# **ENVIRONMENTAL IMPACT STATEMENT CLARIFICATIONS**

## 2 Environmental Impact Statement clarifications

Figure 2-3 Typical over station development interface (not to scale)

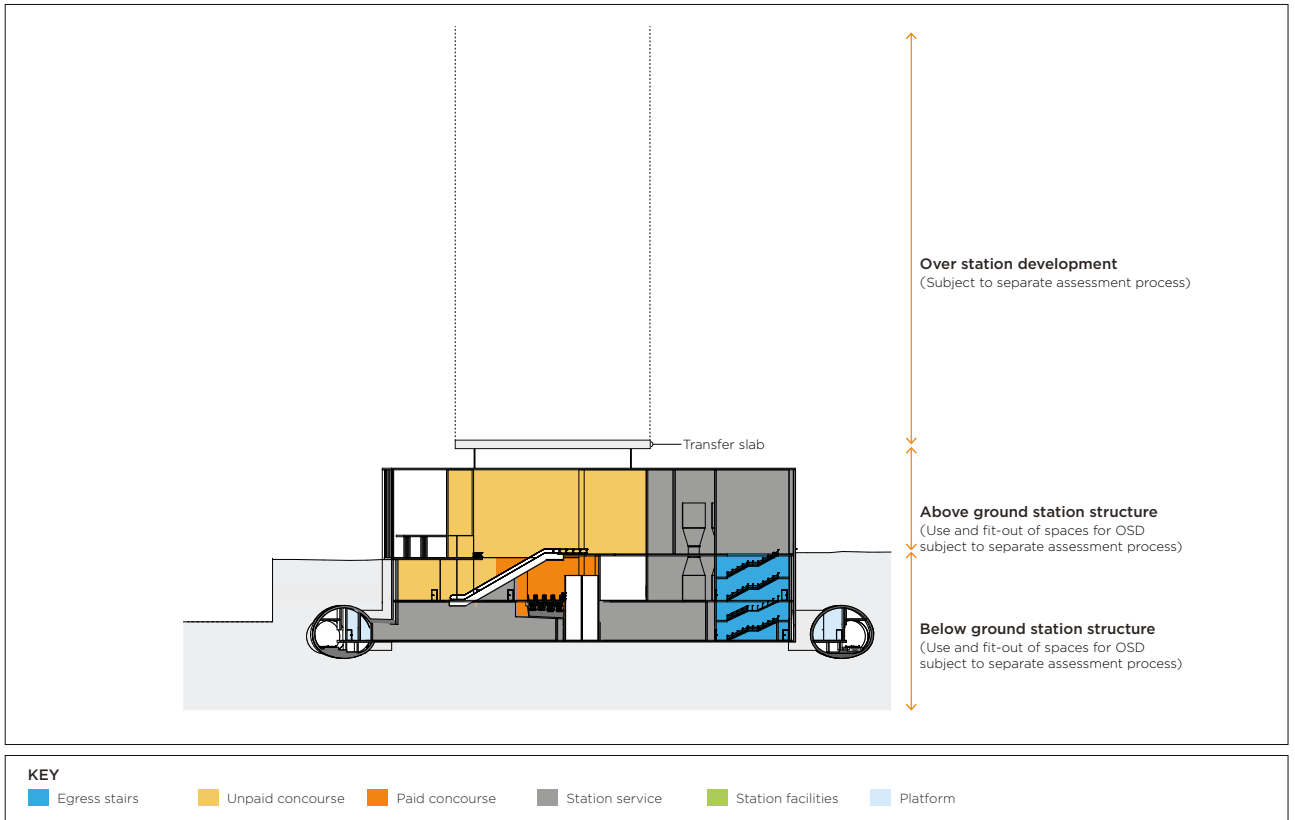
Provision of space for these elements has been made within the building footprints presented and assessed as part of the Environmental Impact Statement. The proposed location of these elements is to be finalised as part of the detailed design and may result in changes or clarifications to the section diagrams contained in this report and the Environmental Impact Statement.

The Environmental Impact Statement further indicates that over station development above the transfer slab would be subject to a separate assessment process. For clarity, the specific use and fit-out of the spaces below the transfer slab (above ground level, at ground level and below ground level – refer Figure 2-3) does not form part of the project and would be subject to a separate assessment process.

Figure 2-4 Sensitive noise receiver types near northern surface track works

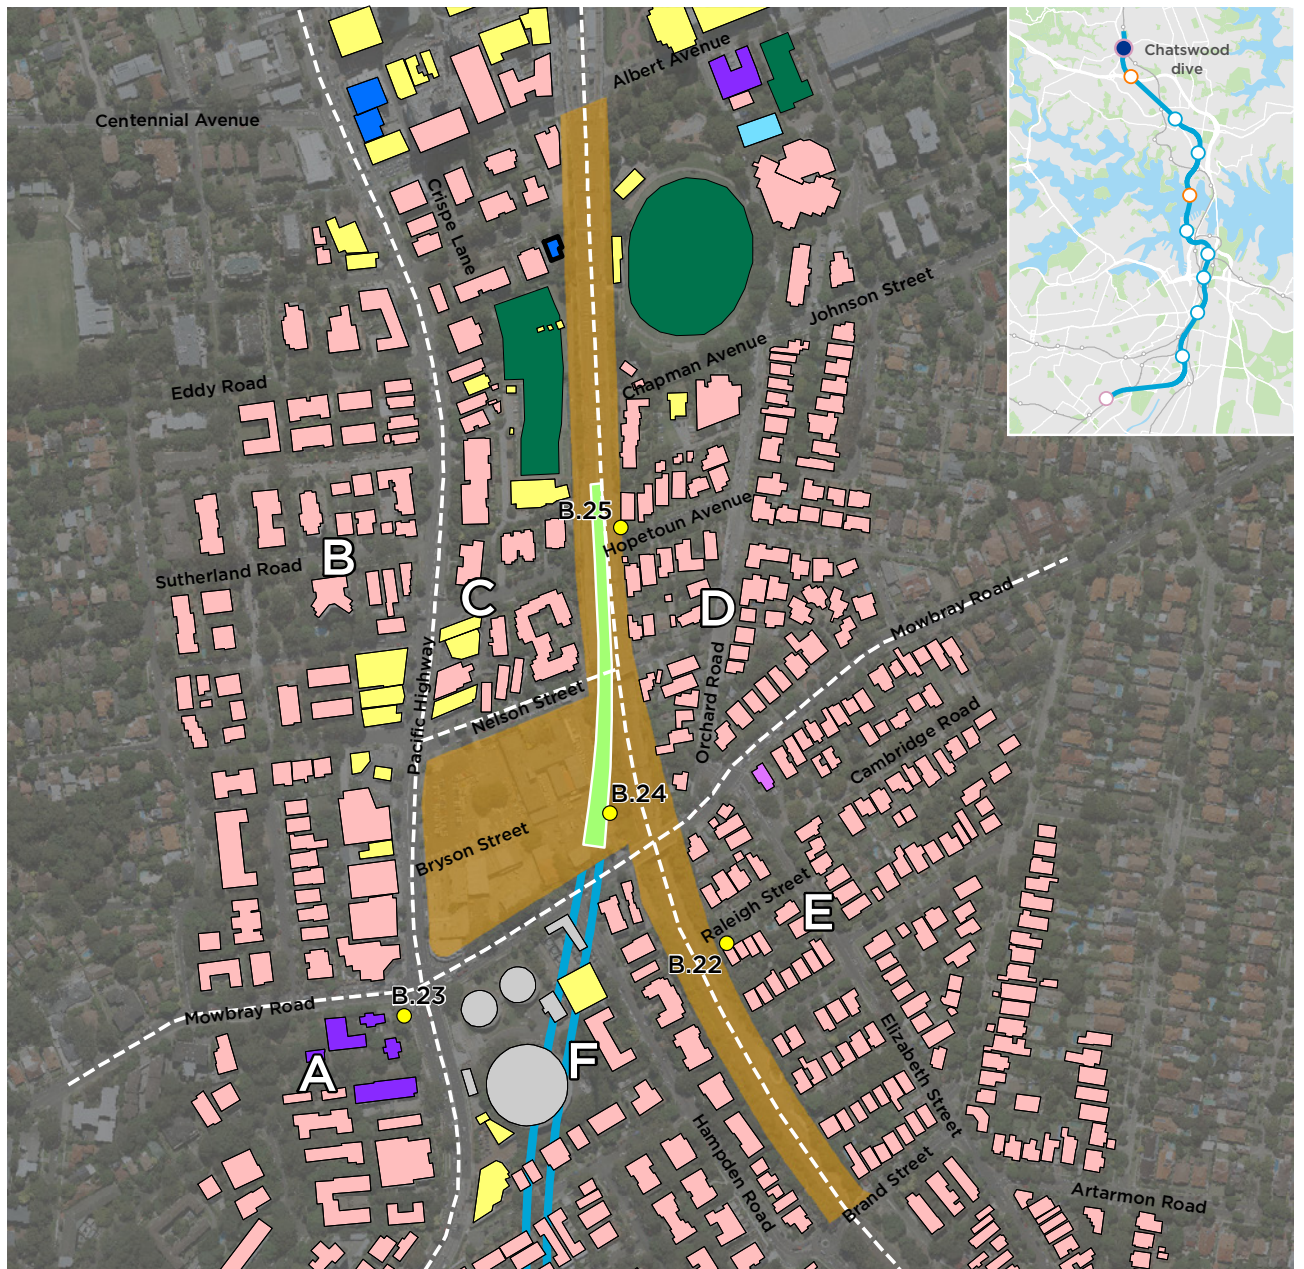
In the vicinity of the northern surface track works, one receiver located to the west on Ellis Street (Area C) was correctly identified and assessed as education. It was also identified as being the closest receiver type of that category in Area C. However, the results were not presented in the summary table in the Environmental Impact Statement.

This receiver location is shown in Figure 2-4, and the predicted airborne noise level exceedances for this receiver are shown in Table 2-1.
